Proposed Residential Development, Kingsway, Burnage

Highways Technical Note

Response to Highways Comments from Manchester City Council and Transport for Greater Manchester

31st January 2025

Large Car (2006)
Overall Length 5.079m
Overall Width 1.872m
Overall Body Height 1.525m
Min Body Ground Clearance 0.310m
Max Track Width 1.831m
Lock to lock time 4.00s
Kerb to Kerb Turning Radius 5.900m

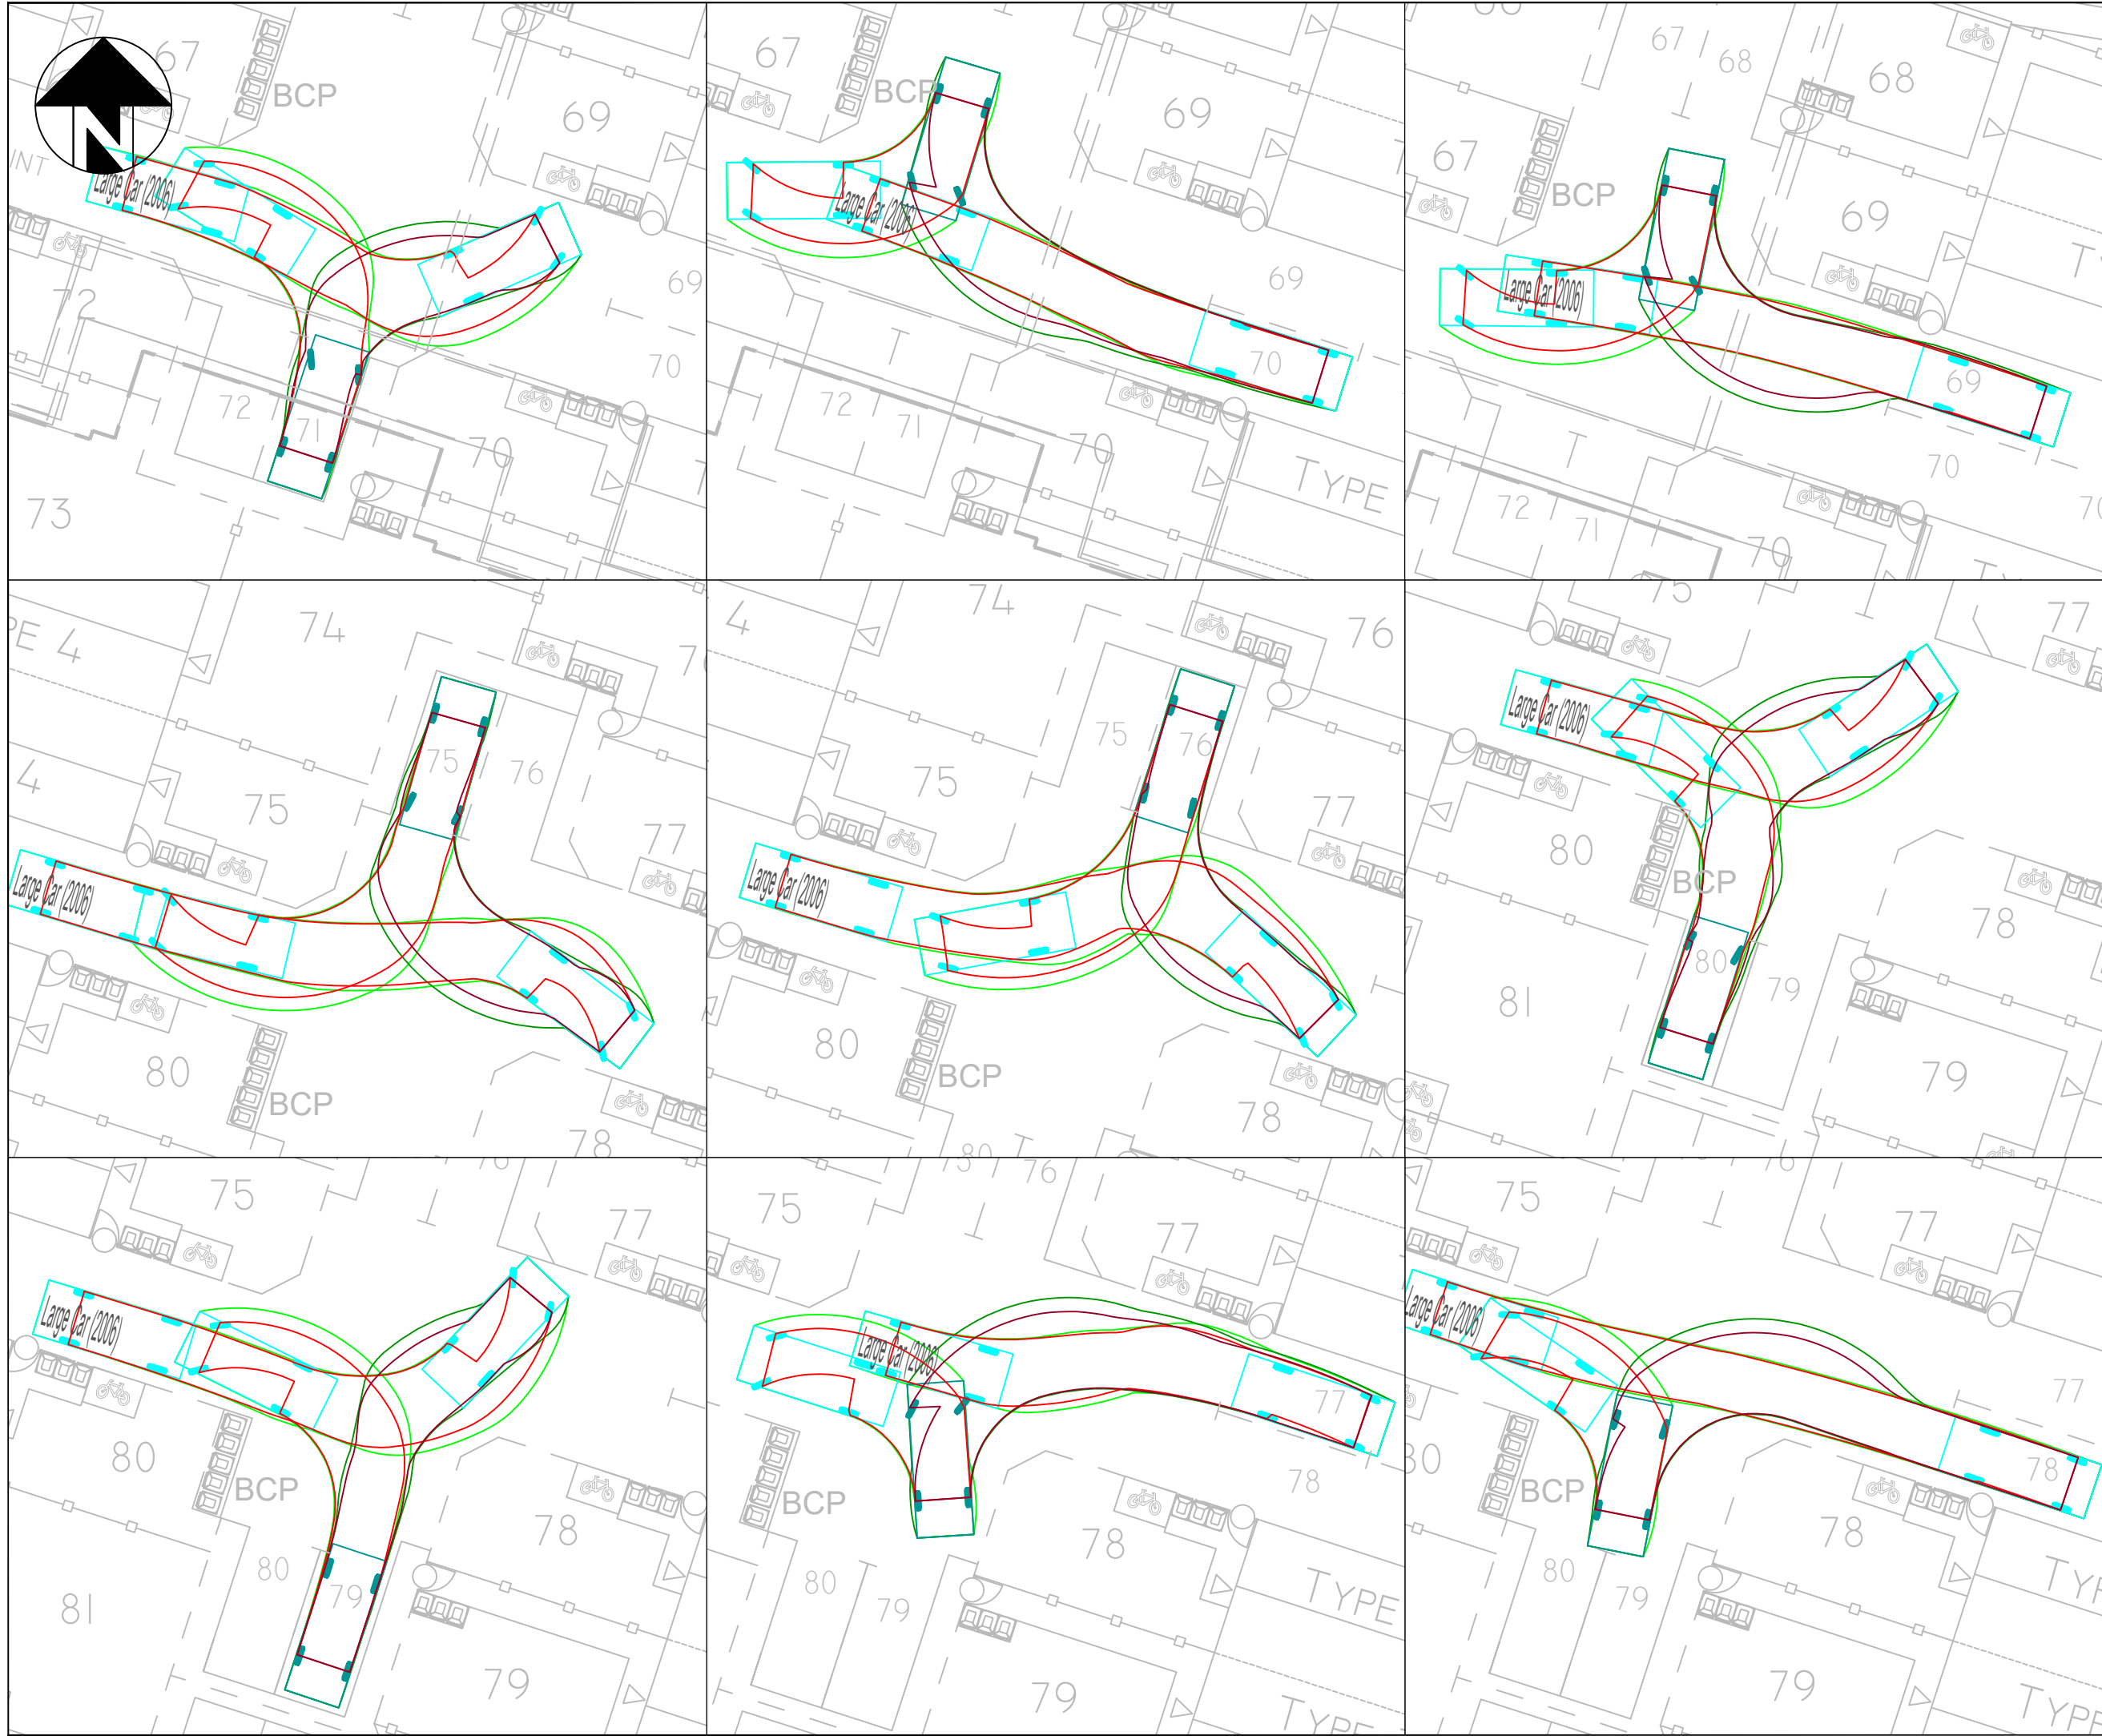
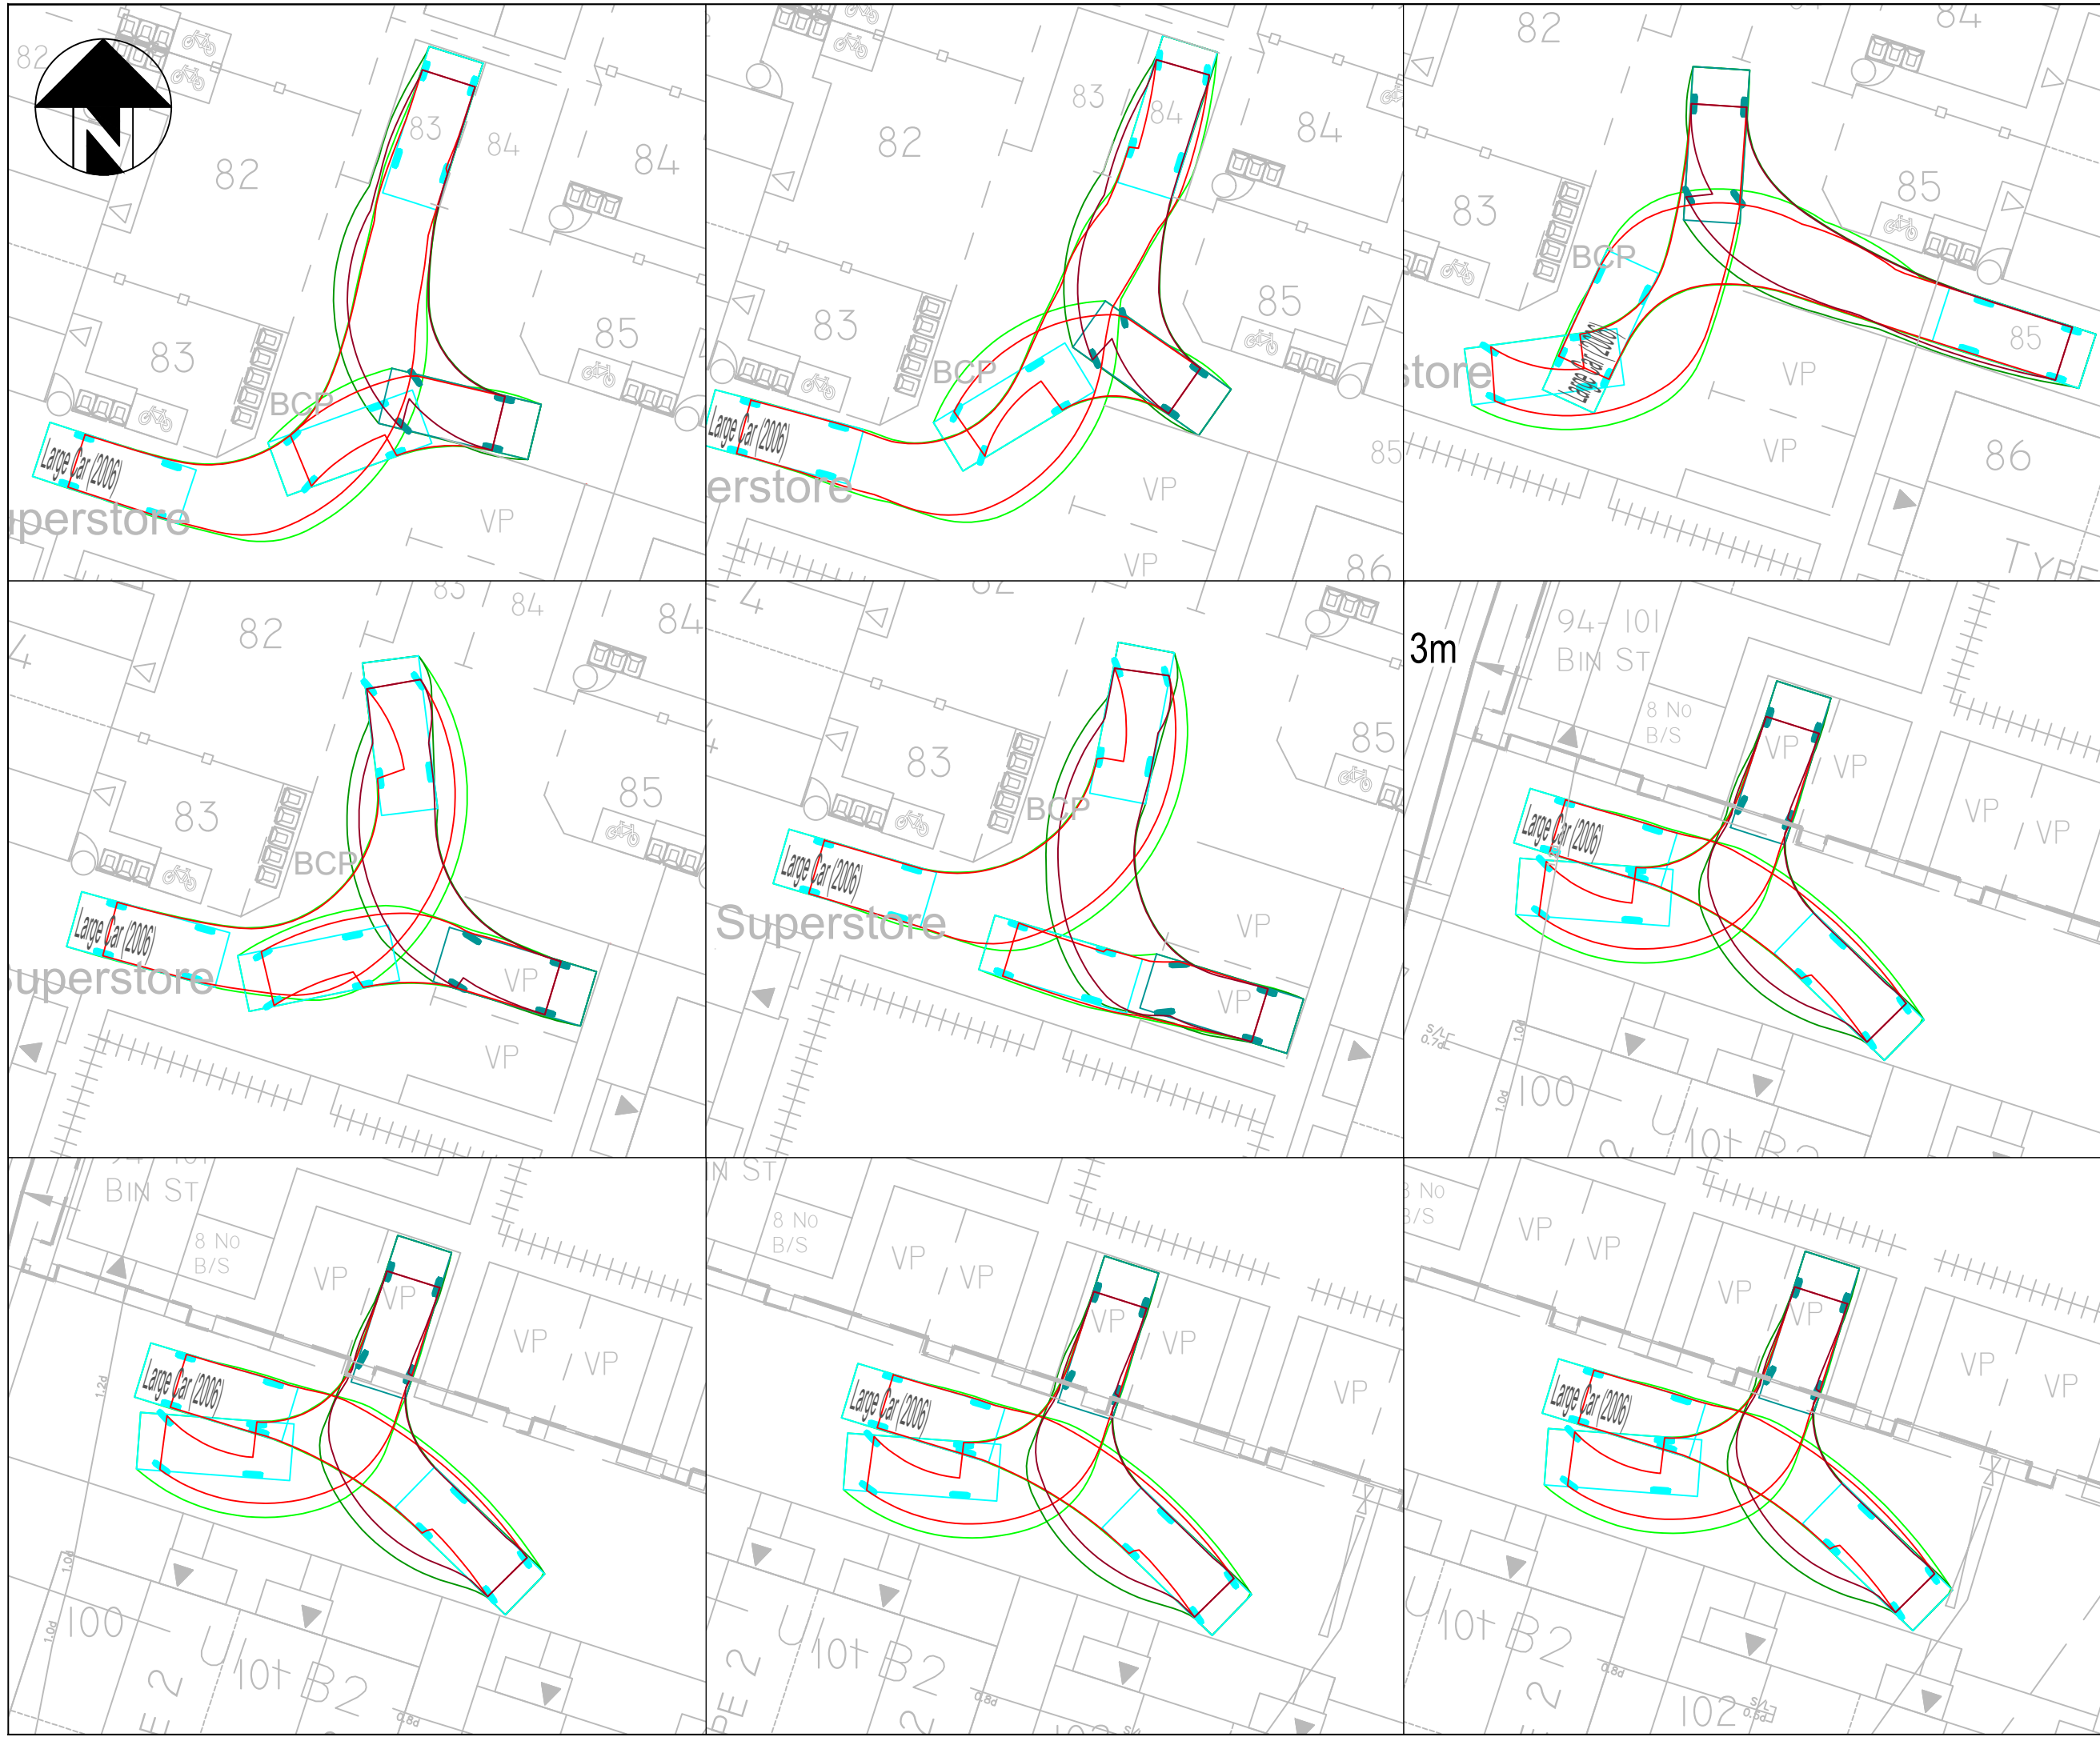
The plan shows allocated courtyard parking with new access points from the access road. It should be ensured that dropped kerbs and tactile paving is provided at each access point and sufficient visibility splays should be in place. It is requested that swept path of vehicles manoeuvring to/from the proposed car park spaces is provided.

As requested, swept path analysis of car parking spaces is provided at [Appendix D](#).
